Project: WEBSTER UNIVERSITY INTERDISCIPLINARY SCIENCE BUILDING
Customer: PARIC CORPORATION
Owner: WEBSTER UNIVERSITY
Location: WEBSTER GROVES, MO 63119
Dwn: TLI Date: 05/23/2016 Ckd: LJ Date: 05/30/2016
Job No. A16013 BAT: DWG#: E2A

SUBMITTAL IDENTIFICATION SHEET

SHOP DRAWING / SUBMITTAL REVIEW

- ☐ NO EXCEPTION TAKEN
☒ EXCEPTIONS NOTED, RESUBMITTAL NOT REQUIRED
- ☐ REJECTED
☐ REVIEWED FOR INFORMATION ONLY
- ☐ REVISE AND RESUBMIT AS NOTED

Project: WEBSTER UNIVERSITY INTERDISCIPLINARY SCIENCE BUILDING
Customer: PARIC CORPORATION
Owner: WEBSTER UNIVERSITY
Location: WEBSTER GROVES, MO 63119
Dwn: ZZ Date: 05/30/16 Ckd: LJ Date: 05/30/16
Job No. A16013 BAT: DWG#: E2F

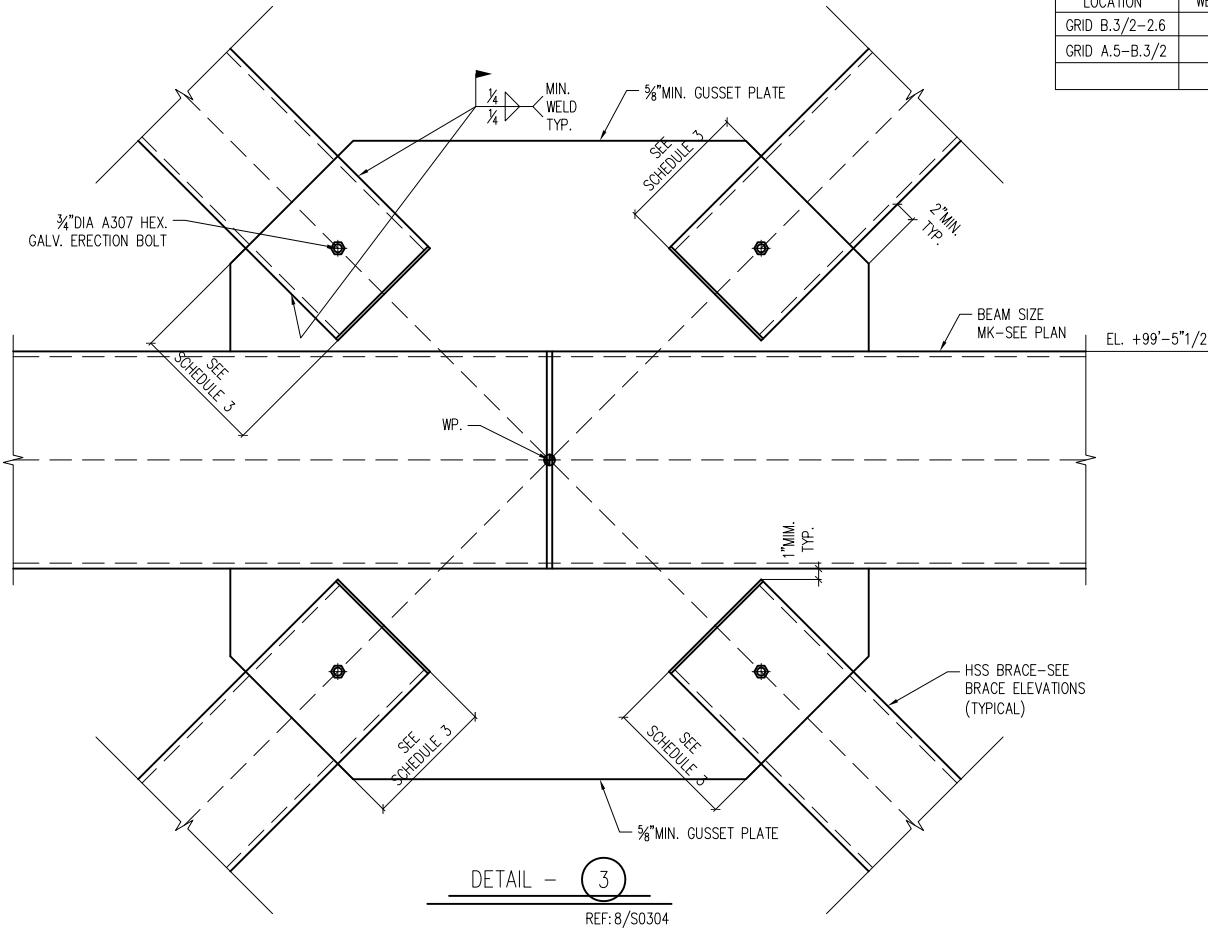
VERIFY ANGLES DO NOT CONFLICT WITH STAIR STRINGER CONNECTIONS

ATLAS IRON WORKS ST. LOUIS, MO.							
Project:	WEBSTER UNIVERSITY INTERDISCIPLINARY SCIENCE BUILDING						
Customer:	PARIC CORPORATION						
Owner:	WEBSTER UNIVERSITY						
Location:	WEBSTER GUYOVES, MO 63119						
Dwn:	TLI	Date:	05/27/2016	Ckd:	LJ	Date:	05/30/2016
Job No.		A16013		RAT:		DWGS#: 201

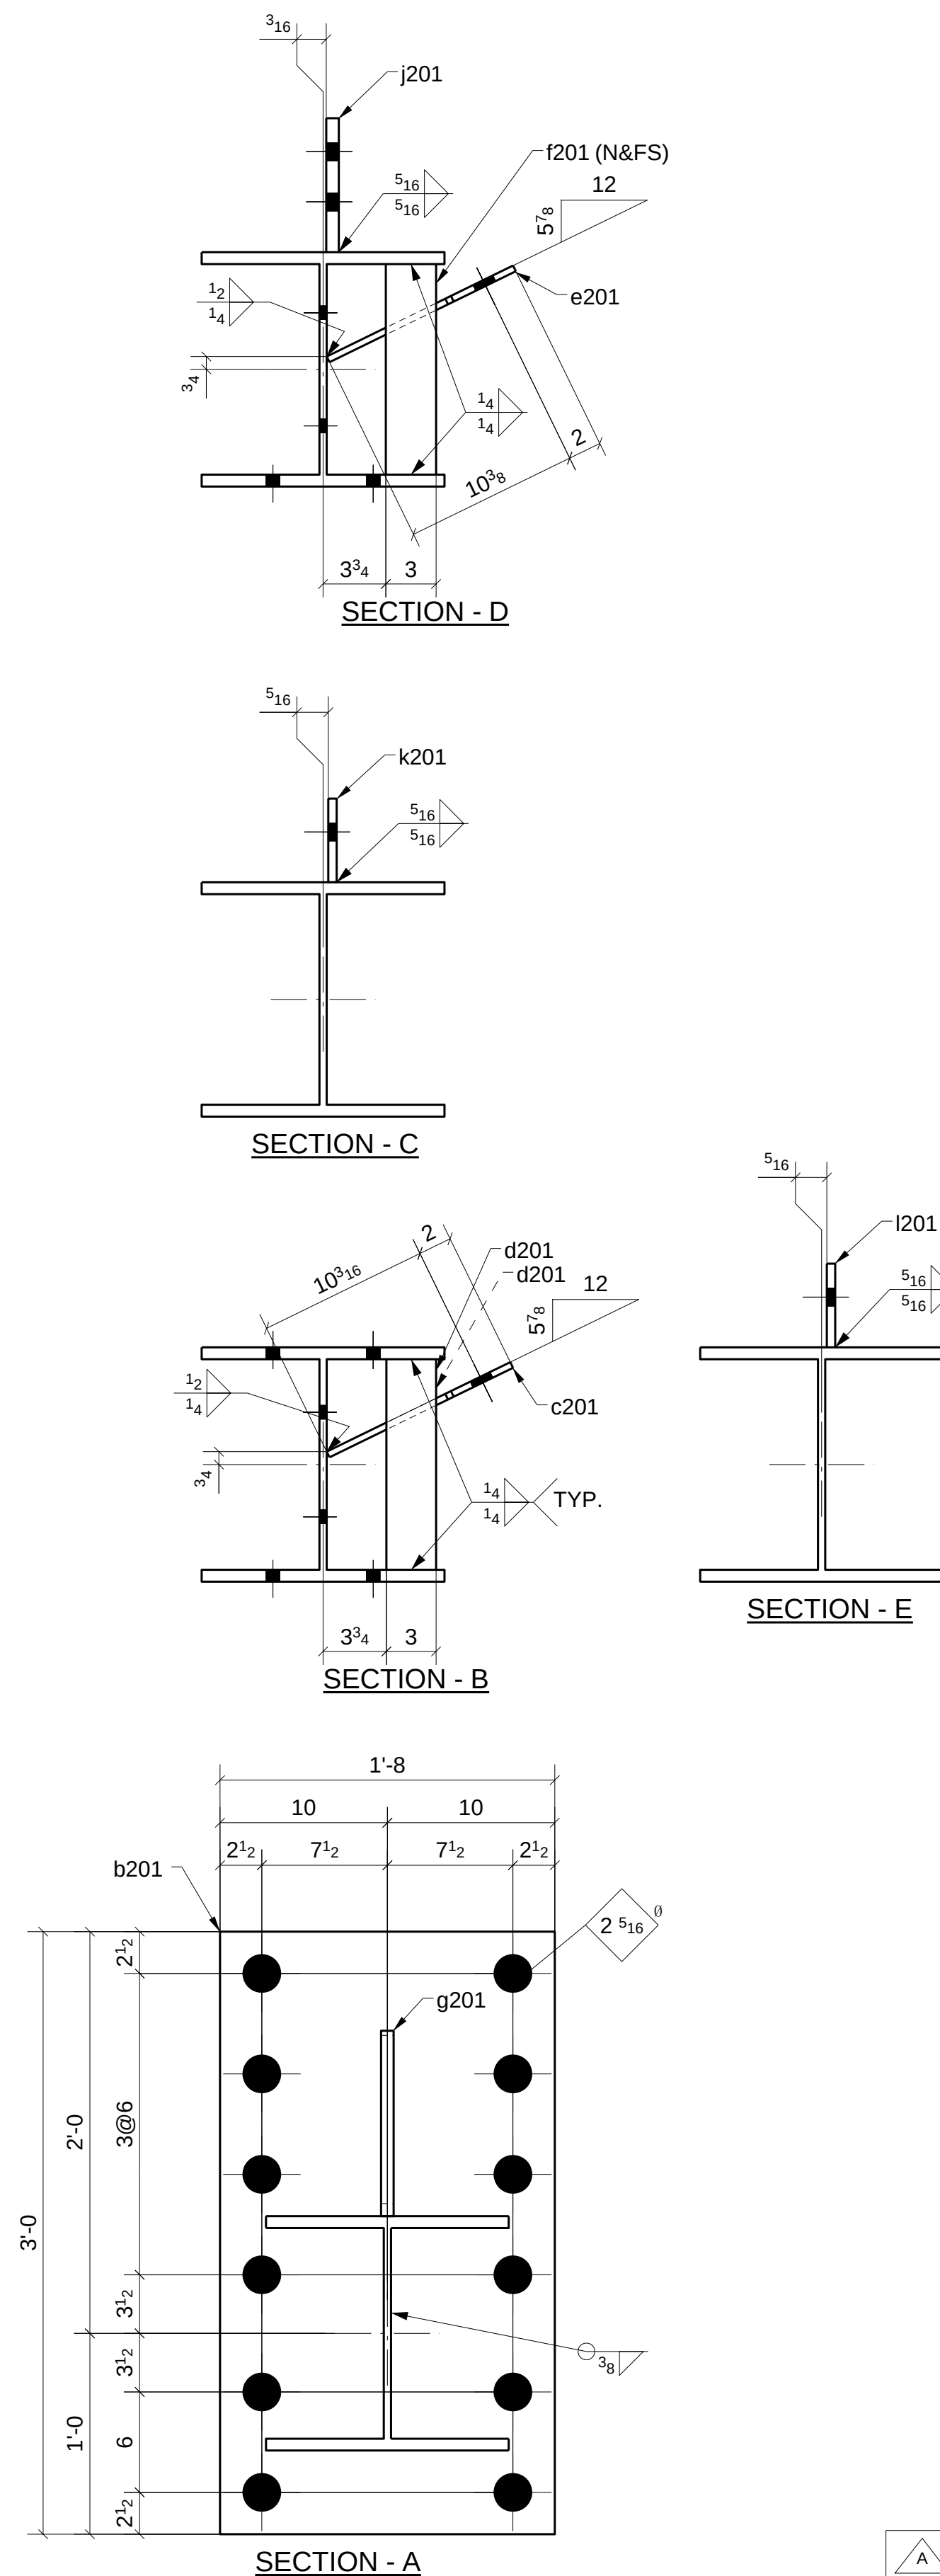
SHOP BOLT IN SLOTTED HOLE
NEED "HAND TIGHTEN"

ONE - COLUMN ~ 207A
LOCATION: ONE @ 1.6/C (REF: E2A,E2B)

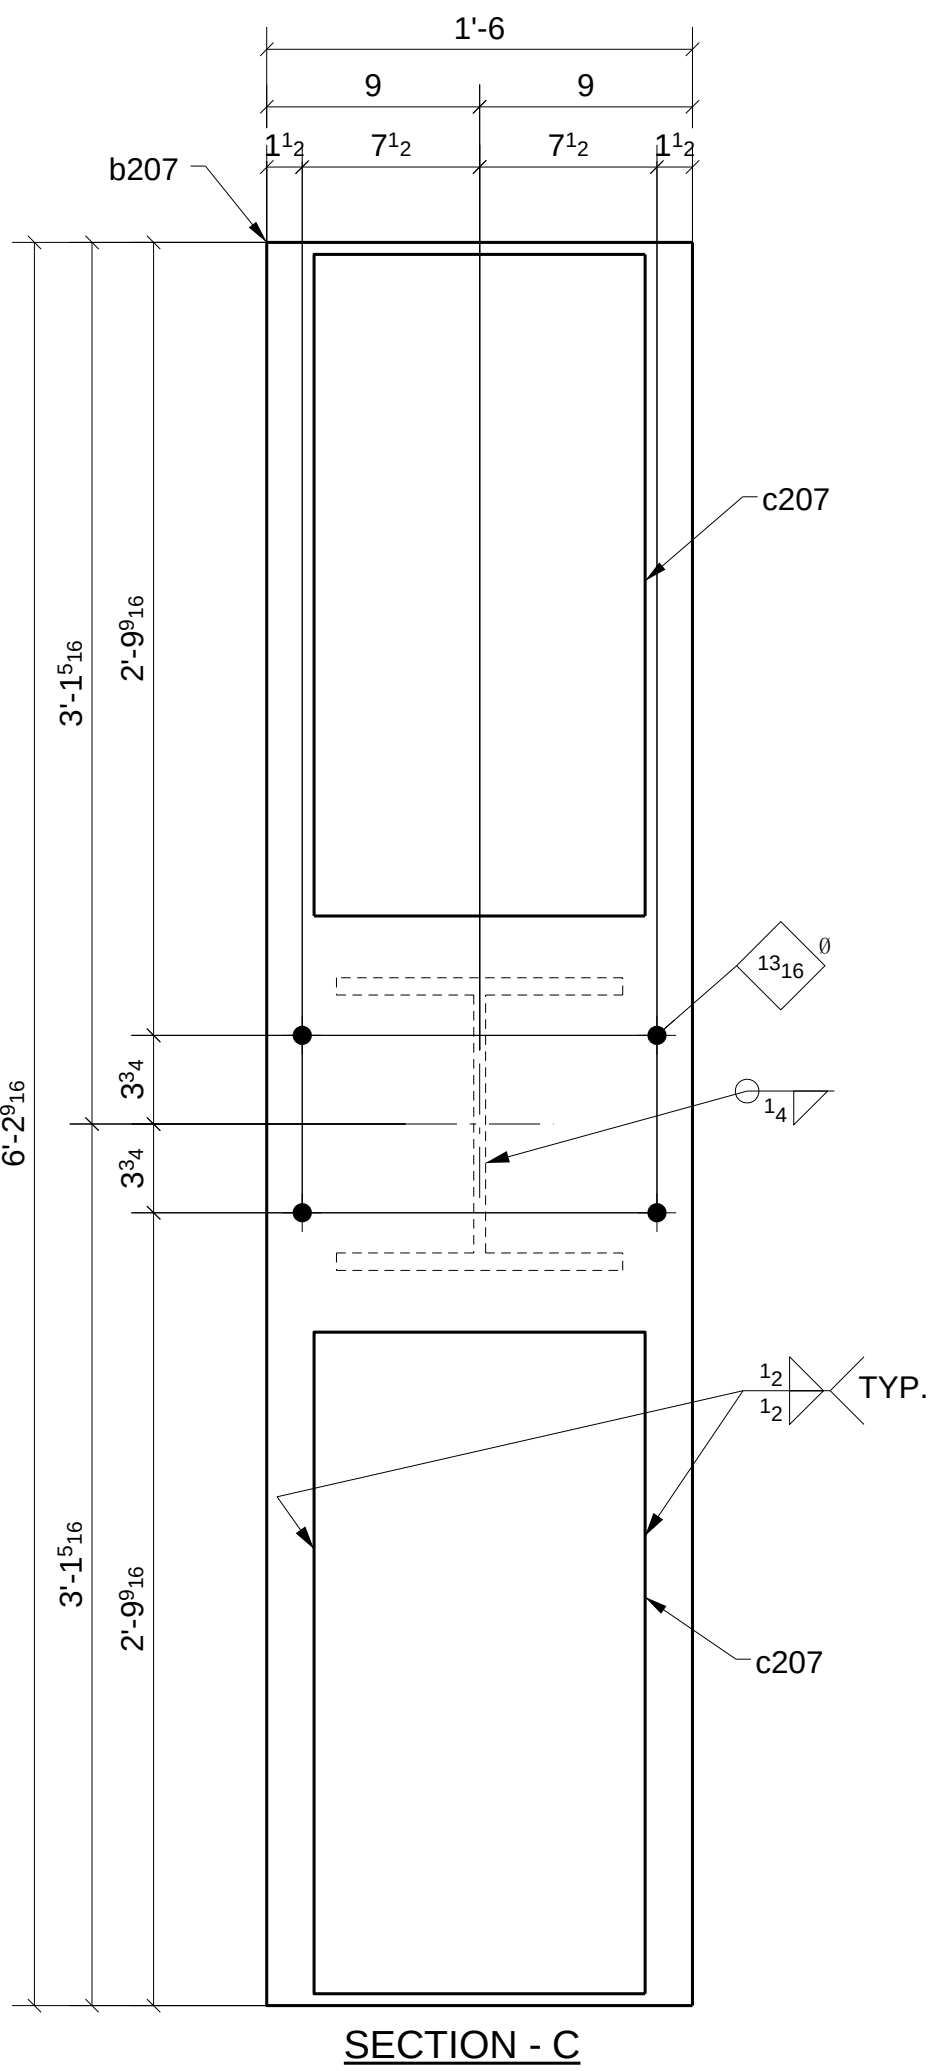
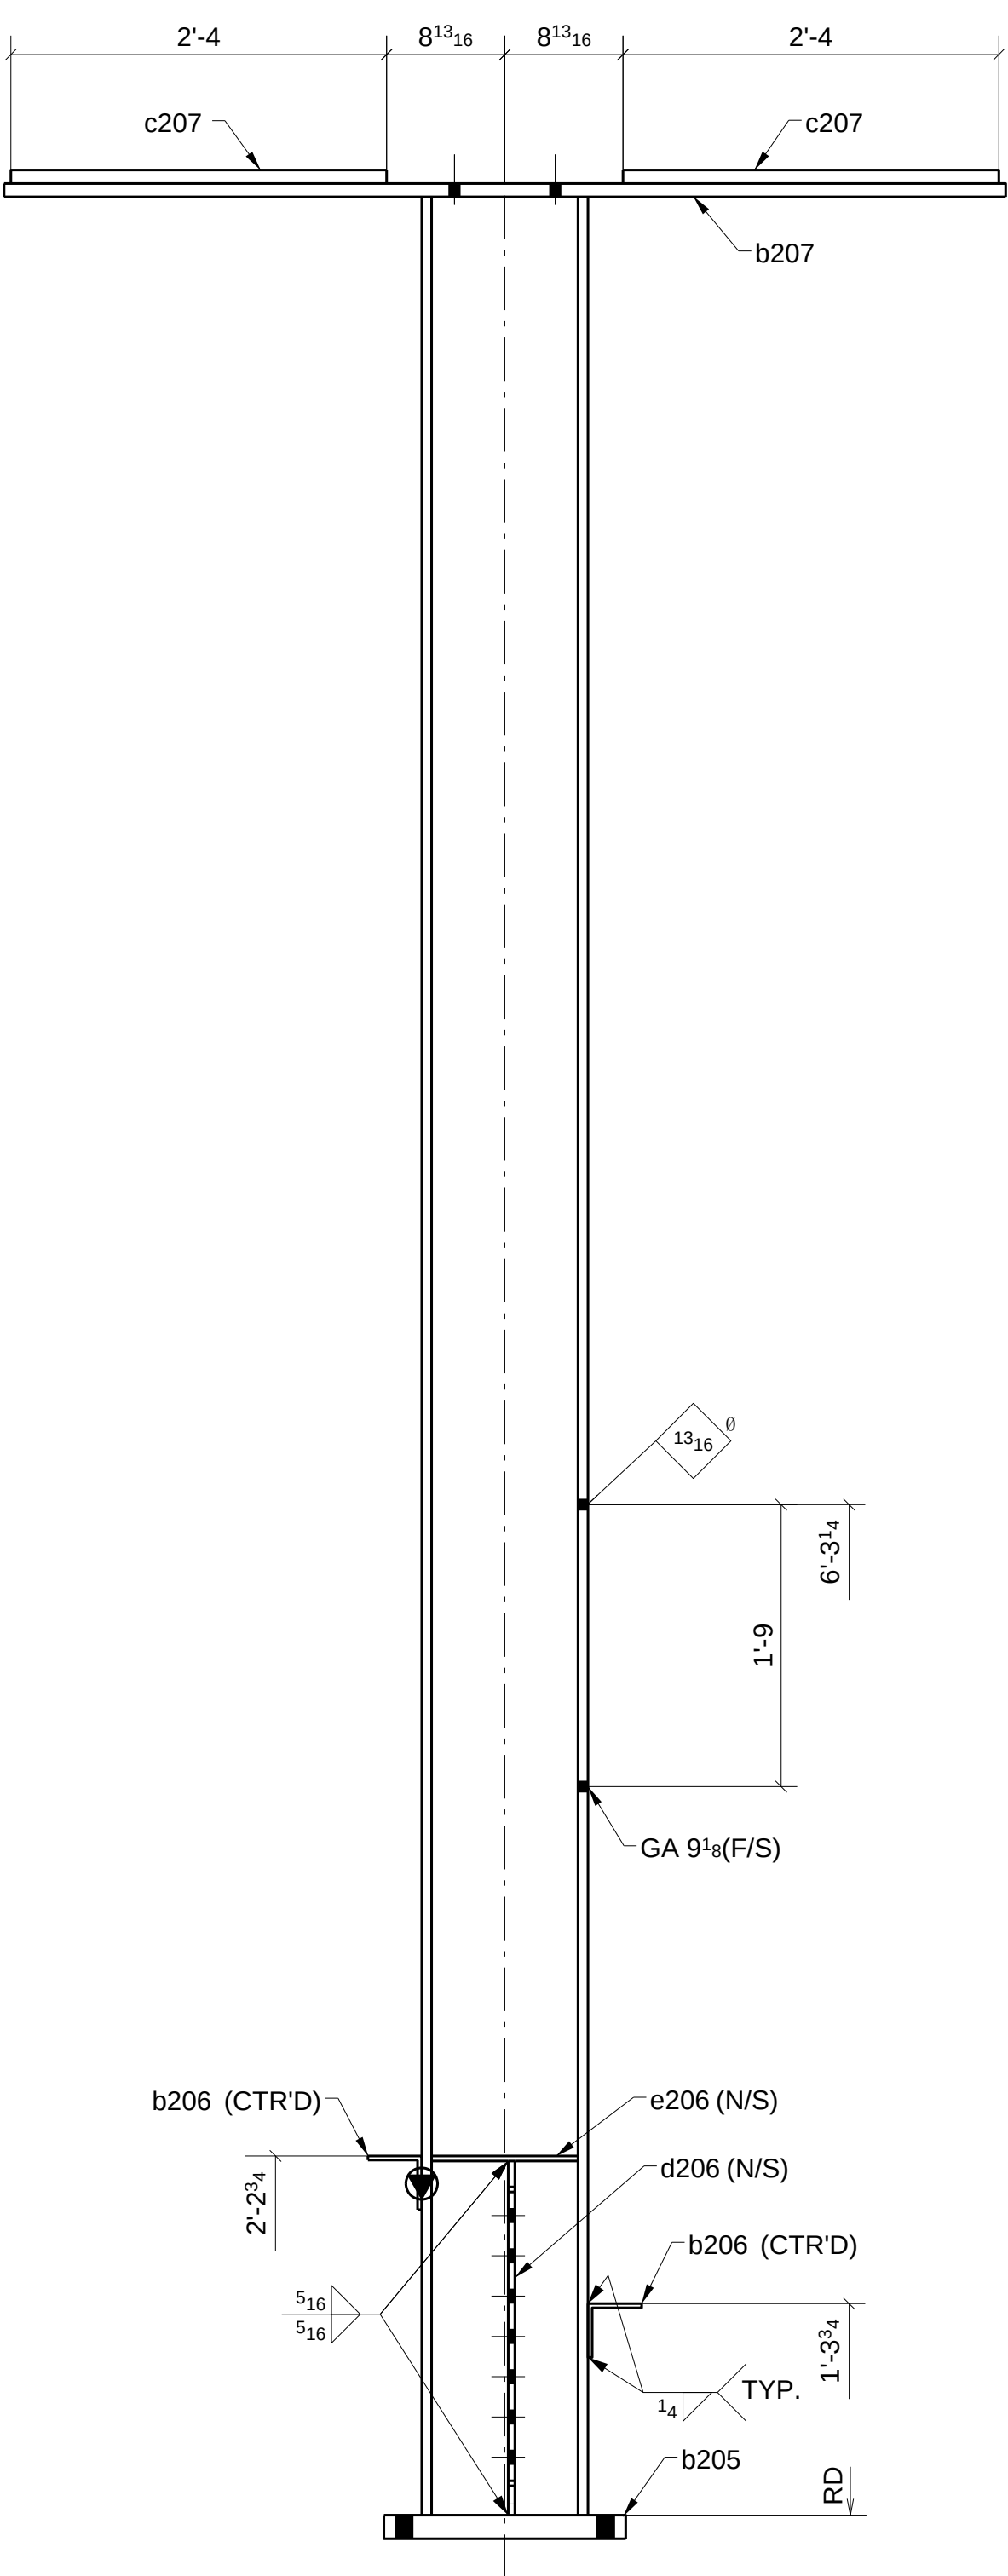
SHOP BOLT IN SLOTTED HOLE
NEED "HAND TIGHTEN"
